AGENDA – WORKSHOP OF THE PLANNING & ZONING COMMISSION OF THE CITY OF PEARLAND, TEXAS, TO BE HELD ON MONDAY, JUNE 15, 2009, AT 6:00 P.M., IN THE COUNCIL CHAMBERS, CITY HALL, 3519 LIBERTY DRIVE, PEARLAND, TEXAS

- 1. COMMISSION INPUT AND DISCUSSION: REGARDING PEARLAND TOWN CENTER PD AMENDMENT FOR SIGNAGE.**

SUBJECT: Pearland Town Center PD Amendment.

**PEARLAND TOWN CENTER
PUD (PD District) Ordinance**

Exhibit B Interior Project Boundary

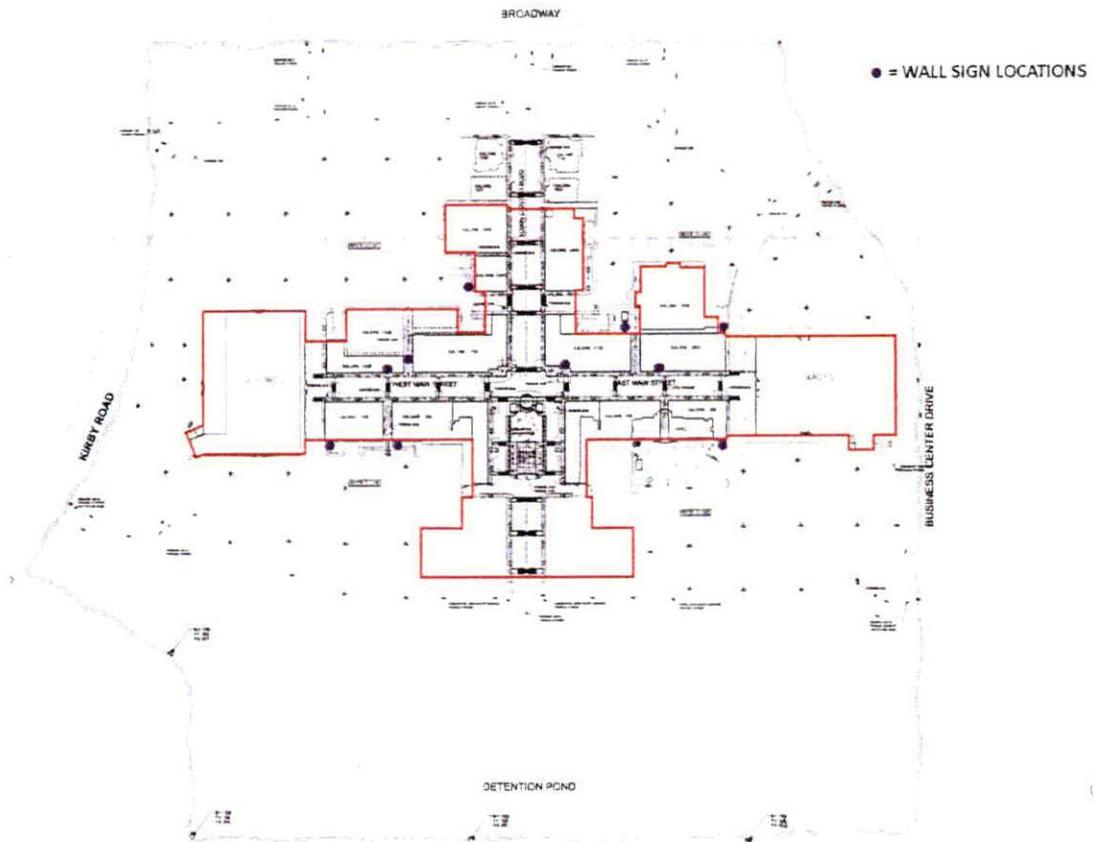
The applicant is requesting a workshop for the purposes of amending the Pearland Town Center PD to allow off-premise signs within the project boundaries as shown in Exhibit B, on page 38 of the PD Document.

The applicant is proposing off-premise or off-site free standing and wall signage. Staff believes that the signage located on the interior facades (not visible from the outer parking lots, public streets, and periphery of Pearland Town Center PD) are similar to the interior signage within an enclosed mall.

Therefore, this would not have any negative impact if the proposed signage is not visible from the outer parking lots, streets, and periphery. Staff recommends that language be added that signage within the project boundary not be visible from the surrounding parking lot, and public streets or anywhere in the project area located outside the project boundary lines, as shown in exhibit B. In addition, the signage shall not be placed on the outer facades of the buildings that are located within the project boundary lines.
